**PLANNED UNIT DEVELOPMENT &
SIDEWALK WAIVER REQUEST
STAFF REPORT**

Date: April 20, 2017

Kimberly Knowles.

Southeast corner of Airport Boulevard and Thrift Street.

SITE PLAN

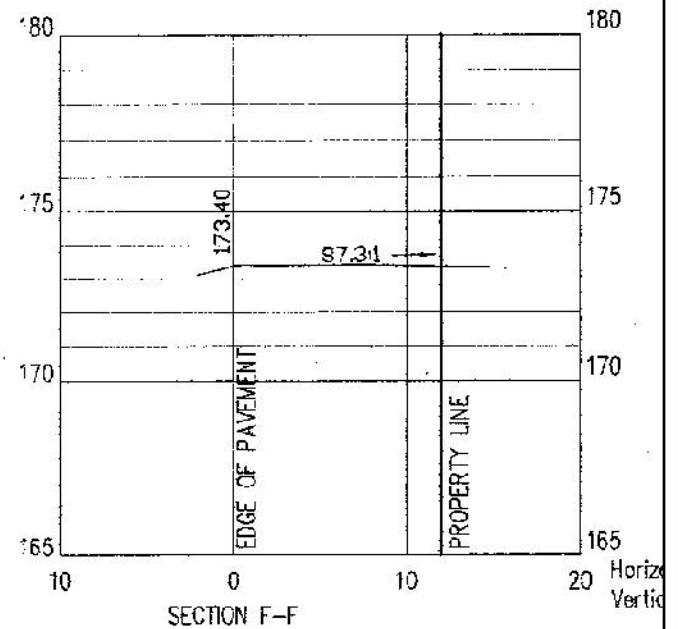
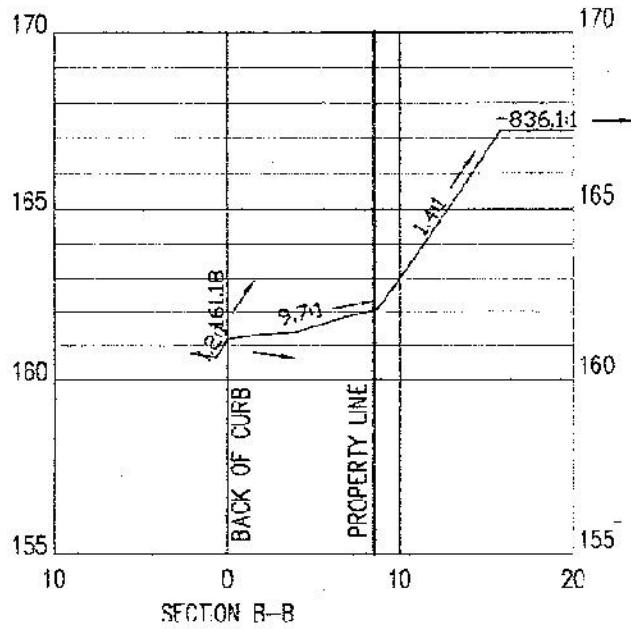
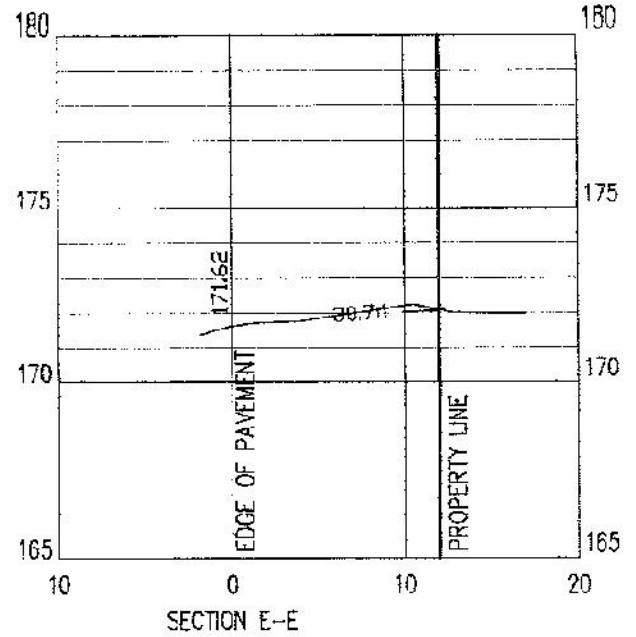
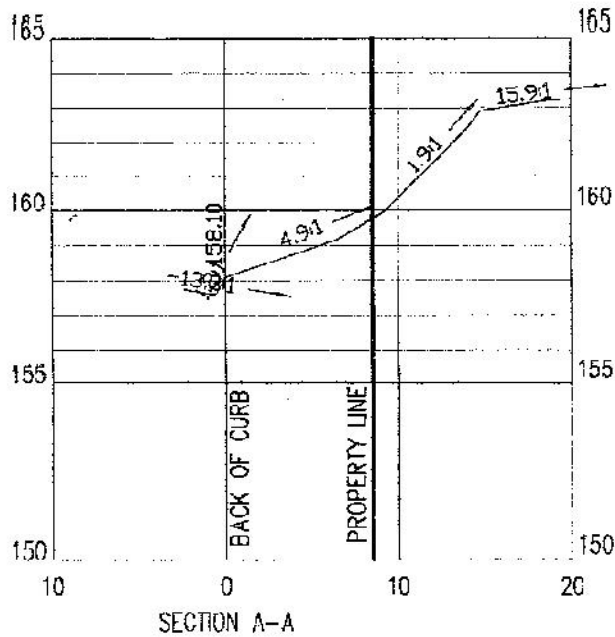
As no relief from building setback lines is requested, the site plan should be revised to indicate a 25' front setback line along Airport Boulevard for all four lots, and an 11'-1" side street yard setback along Thrift Street for Lot 1. A 6'-10" side yard setback line should be illustrated along the East line of Lot 1. Lots 2, 3 and 4 would be required a combined side yard total of 16'-8", with 7'-2" being the minimum allowed on one side. A note should be placed on the site plan stating these allowances for Lots 2, 3 and 4. Also, since no increased site coverage allowance is requested, a note should be placed on the site plan stating that all lots are limited to a maximum site coverage of 35%. As the driveway accessing all four lots is contained within an easement, a note should be placed on the site plan stating that no structures may be constructed or placed within this easement.

The site plan should be revised to label the Thrift Street right-of-way width. And if the Sidewalk Waiver request is denied, the site plan should be revised to indicate a compliant public sidewalk in those areas where the Waiver is denied.

- 1) placement of a note on the site plan stating that Lots 1 – 4 are denied direct access to Airport Boulevard;
- 2) revision of the site plan to illustrate a 25' minimum building setback line along Airport Boulevard for all four lots;

- 3) revision of the site plan to illustrate an 11'-1" minimum building setback line along Thrift Street for Lot 1;
- 4) revision of the site plan to illustrate a 6'-10" side yard setback for Lot 1 along its East side;

- 5) placement of a note on the site plan stating that Lot 2, 3 and 4 must maintain a combined side yard total of 16'-8", with a minimum side yard setback of 7'-2" on one side;

- 6) placement of a note on the site plan stating that all lots are limited to a 35% maximum site coverage by all structures;
- 7) placement of a note on the site plan stating that no structure may be placed or constructed within the common driveway easement;

- 8) revision of the site plan to label the Thrift Street right-of-way width;
- 9) revision of the site plan to illustrate a public sidewalk within any areas where the Sidewalk Waiver might be denied;
